1 DEFERRED REPORT: PLANNING PROPOSAL - 2-14 TENNYSON ROAD, GLADESVILLE

Report prepared by: Senior Strategic Planner
File No.: GRP/09/6/11 - BP18/329

2-14 Tennyson Road, Gladesville
Peer Review

Figure 3: The proponent's original preferred urban form model showing the disposition of the buildings, private open space and buffer to the existing residential area.

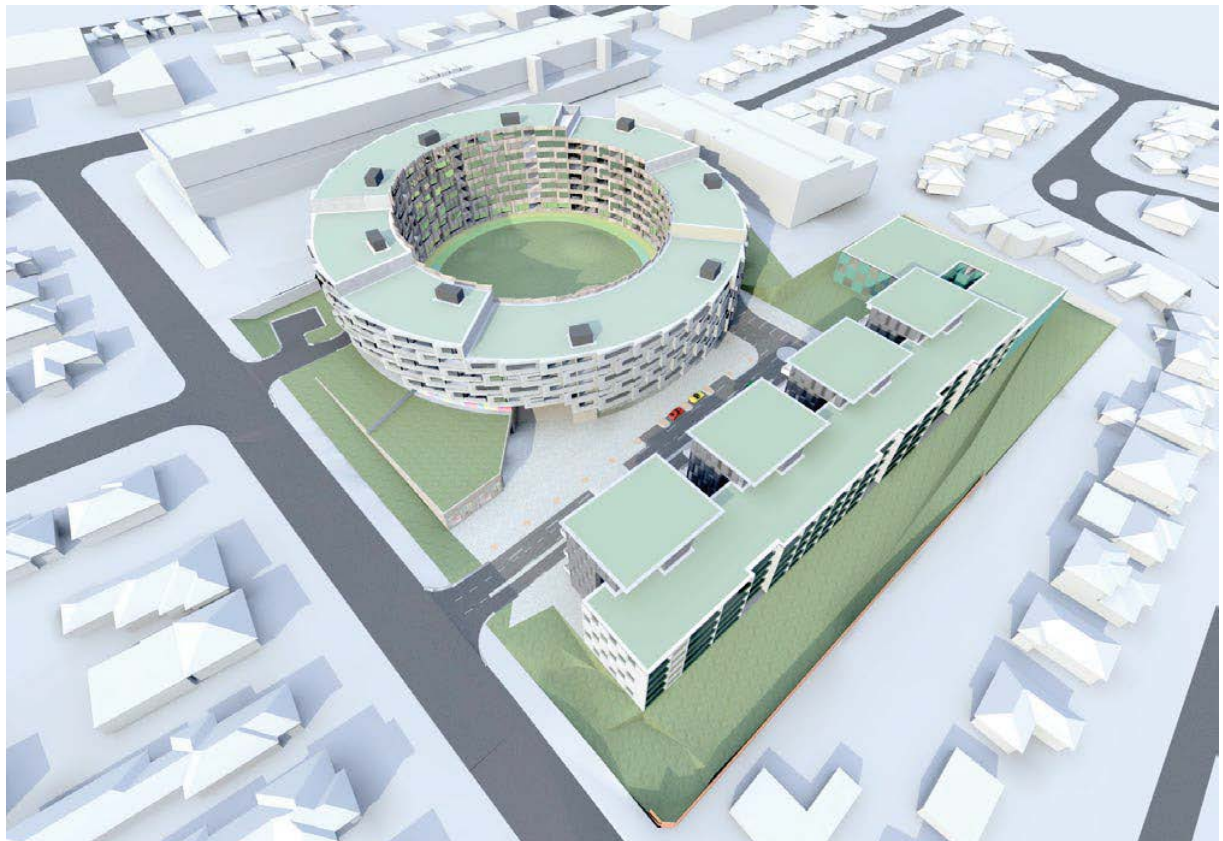
Council considered a report on the Planning Proposal on 25 February 2014 and resolved to **not** to seek a Gateway Determination due to adverse traffic and amenity issues, as well as inconsistencies with State and Council planning strategies. The proponent then applied to the NSW Department of Planning and Environment for a Gateway Determination Review.

Figure 4: The proponent's original scheme (top) and the preferred scheme (bottom) that was exhibited for public comment.

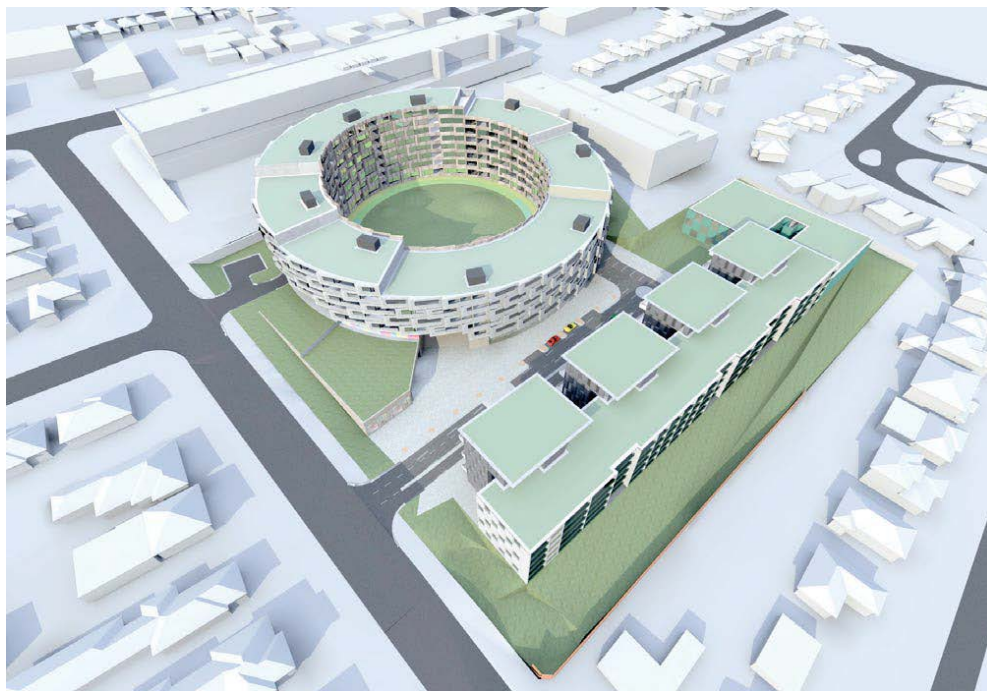
The current proposal description is less certain than that originally proposed. There is far less detail than what was described in the original proposal (Table 1). Whilst the number of units is similar (about 390 total) the documentation around commercial, retail and community uses is not clear. In the Urban Design Report that accompanied the Proposal, there are calculations of floor space for a combined retail and car parking category and a residential and community category for 2-12 Tennyson Road. There is no reference to a retail category for 14 Tennyson Road despite floor plans and sections showing retail floor space. In the Traffic Impact Assessment, a commercial floor space of around 2,187m² is used as the basis for calculating commercial trips generation for modelling purposes.

The Proposal had changed significantly since its initial submission (Figure 3) to Council in 2013. The general form of the scheme that was exhibited for public comment is shown in Figure 4, together with the original scheme for comparison.

Figure 6.1: Tennyson Road/Victoria Road Intersection Volume (2016)

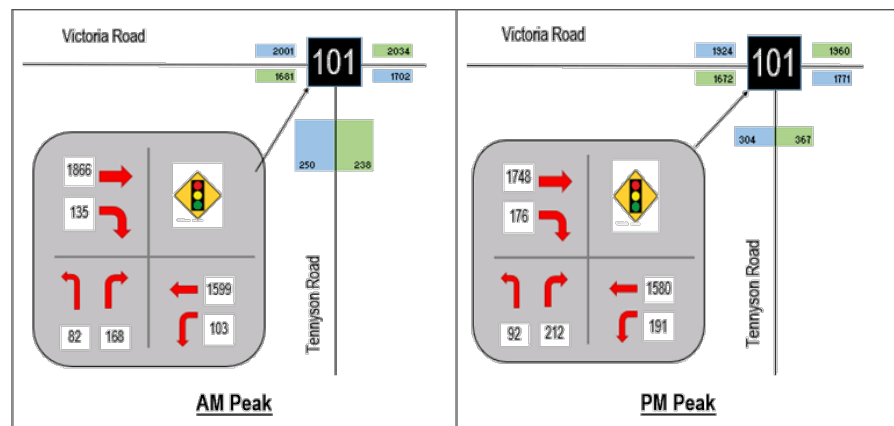
The existing volumes were adopted from the Traffix report. The Tennyson Road/Victoria Road intersection was surveyed in November 2016 for both AM and PM peak; however, the rest of the intersections at Searle Street and Morrison Road were surveyed in 2013, for which the data is only available for PM peak.

With the limited data available, sensitivity tests for both the AM and PM peak intersection performance at Tennyson Road/Victoria Road show that the PM peak is the more critical peak. Therefore, only PM peak was analysed. Detailed SIDRA summary is provided in Appendix A.

Figure 6.5: Tennyson Road/Victoria Road Intersection Proposed Upgrade

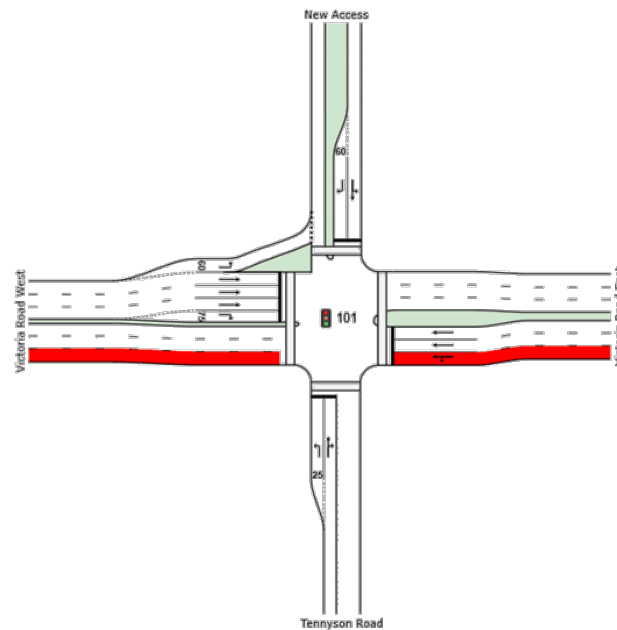
The SIDRA assessment for both years 2020 and 2025 for Tennyson Road/Victoria Road were assessed with the proposed upgrade to a four-approach intersection from the Bunnings precinct study. The proposed intersection layout and signal phasing are shown in Figure 6.5 and Figure 6.6. The signal timing was set to fixed cycle times of 115s and 145s in years 2020 and 2025 due to the signal coordination with the downstream and upstream intersections on Victoria Road. This variation by 15s from the "LX" data provided by Roads and Maritime Services is reasonable because the future cycle times are unknown and the SCATS (Sydney Coordinated Adaptive Traffic System) will adjust signal timing to find the best phasing for individual intersections as well as the local network.
